**BELL BEND NUCLEAR POWER PLANT  
RESPONSE TO SRBC COMMENTS ON THE BBNPP  
WATER MONITORING PLAN  
BNP-2011-124                      Docket No. 52-039**

Responses to SRBC Comments on the BBNPP Water  
Monitoring Plan and Proposed Plan Changes

# ATTACHMENT 1 Bell Bend Nuclear Power Plant Water Flow Diagram

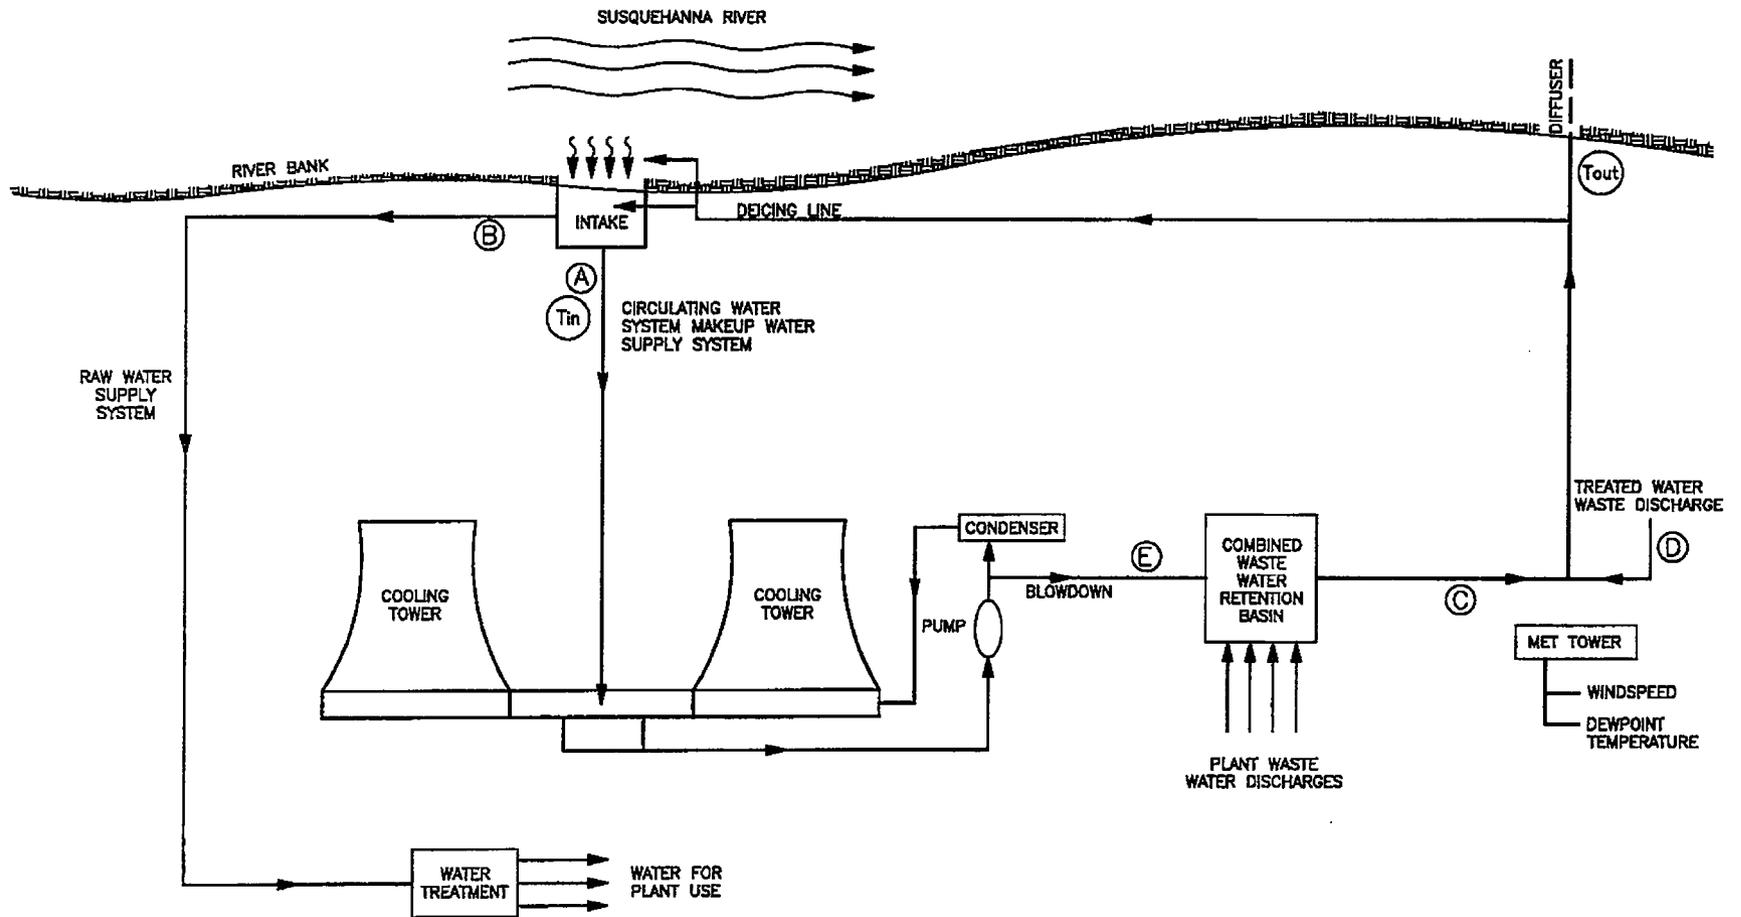
3. Comment: The flow indicator for the cooling tower blowdown should be a monitoring point for the "Water Monitoring Plan for BBNPP," and a backup method should be established in the event that the flow indicator malfunctions.

Response: The cooling tower blowdown will be added as a monitoring point to the Water Monitoring Plan for BBNPP. The backup method to estimate blowdown will be based on using information supplied by the cooling tower vendor including cooling tower evaporation curves to estimate cooling tower evaporation and drift loss. The combined loss from the two towers will be subtracted from the makeup flow from monitoring point A to determine cooling tower blowdown flow.

Plan Change, Attachment 1:

Refer to attached revised diagram which includes cooling tower blowdown flow as Monitoring Point E.
